# PRODUCT BULLETIN

## STANDARDIZATION OF MAIN TUBE & EXTENSION TUBE IN SL-10 SERIES CARGO BARS

### SL-10 LIGHT DUTY PRESSURE CALIBRATION

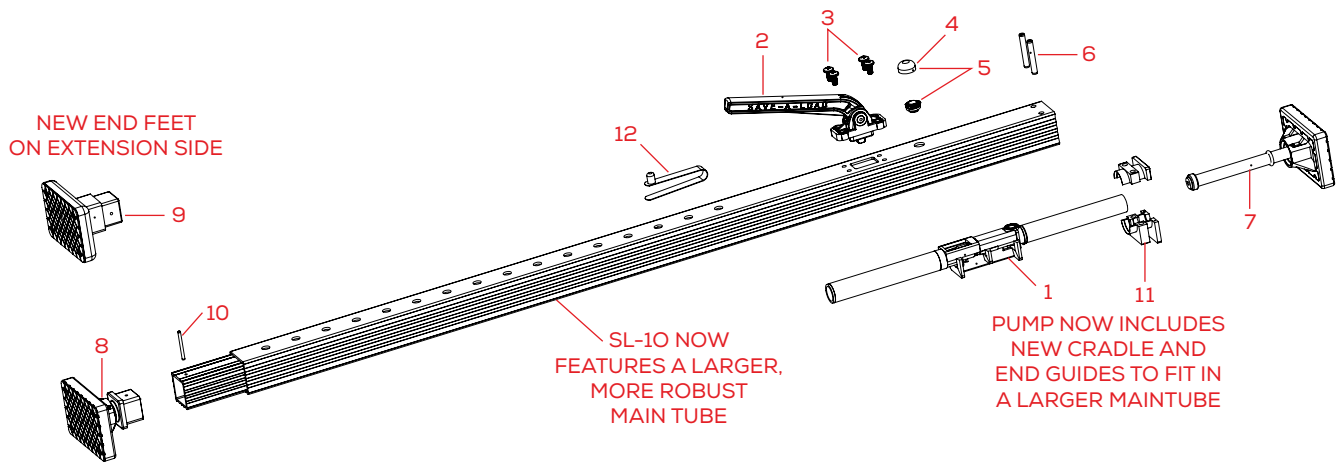
Although the main tube and extension tubes are now standardized, the pressure-limiting valve in SL-10 light-duty bars remains precisely set to a PSI level engineered for secure use in everyday pickups, vans, and SUVs.

PUMP NOW INCLUDES NEW CRADLE AND END GUIDES TO FIT IN A LARGER MAINTUBE

- Holds firmly in place during transport
- Designed to prevent over-pressurization
- Will not damage vehicle walls
- Now includes new end guides/cradle to support a larger tube size
